Project	IEEE 802.16 Broadband Wireless Access Working Group < http://ieee802.org/16 >	
Title	MIMO transmission for UL FAST_FEEDBACK and Fast MIMO Feedback Channels	
Date Submitted	2004-11-15	
Source:	Wen Tong, Peiying Zhu, Ming Jia, Jianglei Ma , Dongsheng Yu, Mo-Han Fong, Hang Zhang and Brian Johnson Nortel Networks 3500 Carling Avenue Ottawa, ON. K2H 8E9 CANADA	Voice: (613)-763-1315 Fax: (613)-765-7723 wentong@nortelnetworks.com
Re:	Response to sponsor ballet	
Abstract	Enhance the UL feedback channels by space time coding The updated revision is in blue font	
Purpose	To incorporate the changes here proposed into the 802.16e D5 draft.	
Notice	This document has been prepared to assist IEEE 802.16. It is offered as a basis for discussion and is not binding on the contributing individual(s) or organization(s). The material in this document is subject to change in form and content after further study. The contributor(s) reserve(s) the right to add, amend or withdraw material contained herein.

MIMO Transmission for UL FAST_FEEDBACK and Fast MIMO Feedback Channels

Figure WWW

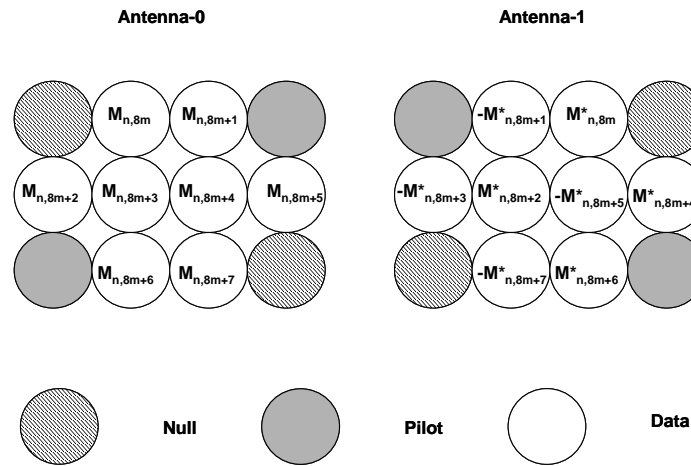
For UL MIMO enabled MSSs (MSSs with two transmit antennas), STC may be applied in the transmissions of uplink feedback channels to improve the coverage. 2xM STTD is implemented (M is the number of receive antennas at BS). With the UL tile allocation shown in figure 249a for PUSC zone, the transmission from antenna-0 is the same as in non-MIMO operation, however, the different sub-carrier mapping method is applied to antenna-1 (see figure WWW).

Figure XXX

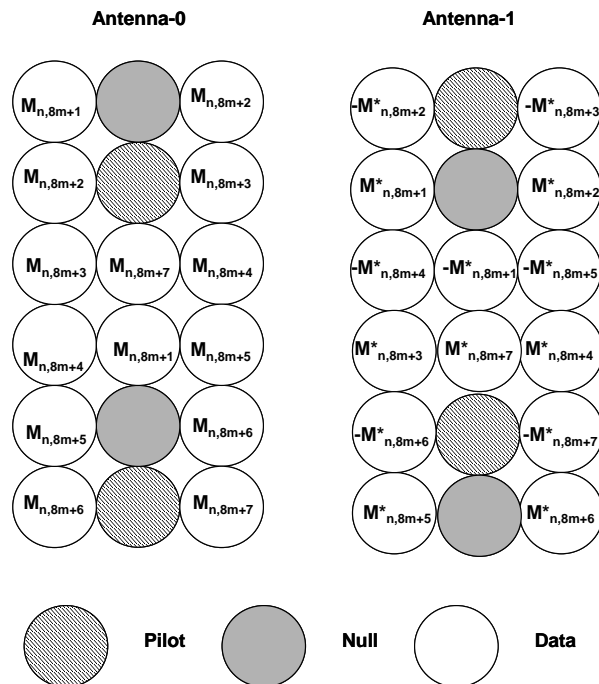
With the UL tile allocation shown in figure 252a for optional PUSC zone, two data sub-carriers should be punctured in each MIMO tile in order to obtain two extra pilot sub-carriers (same requirement for UL MIMO traffic channel). To reduce the impact from the puncturing, the first QPSK symbol (P0) in each orthogonal modulation index is removed (Table 295 and 296c) (see figure XXX). The mini subchannelization scheme described in section 8.4.6.2.4 shall be used with $M=2$, type = 01. CQICH channel shall be allocated simultaneously for two MSS, each uses one of the mini subchannel as specified in CQICH_Enhanced_Alloc_IE().

Figure YYY

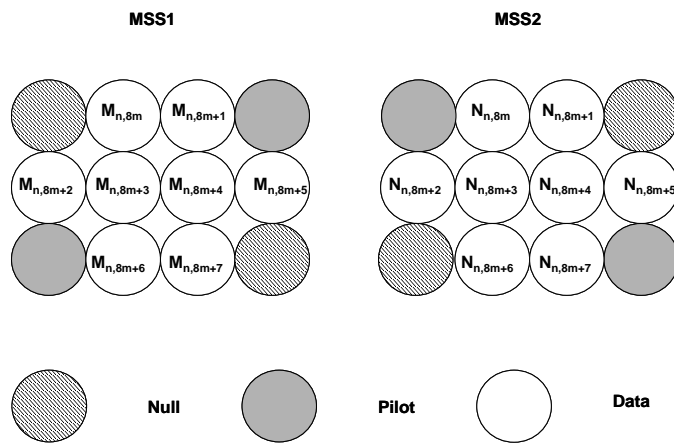
Multi-user collaborative spatial multiplexing can also be applied to uplink feedback channel to reduce the overhead introduced by the uplink feedback channels. In this case, BS assigns the same feedback channel resource to two single antenna MSSs. Each MSS selects the tile patten (pattern A or pattern B) according to the instruction from BS, and transmits the data burst independently with the same modulation and coding scheme for non-MIMO operation. Figure YYY and figure ZZZ show the mapping of the orthogonal modulation index for MSS-1 and MSS-2, where M is the orthogonal modulation index for MSS1 and N is the orthogonal modulation index for MSS2

Figure ZZZ

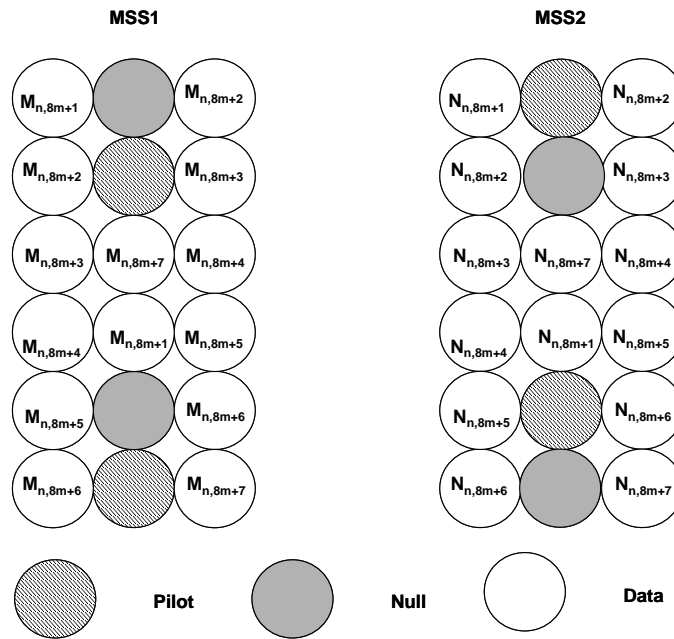
CQICH channel shall be allocated simulatanously for two MSSs, each uses one of the mini subcahnnel as specified in CQICH_Enhanced_Alloc_IE(). The same physical CQICH channel resource can be allocated to another two MSSs through spatial multiplexing. The MSS shall use the pilot pattern as specified in CQICH_Enhanced_Alloc_IE().
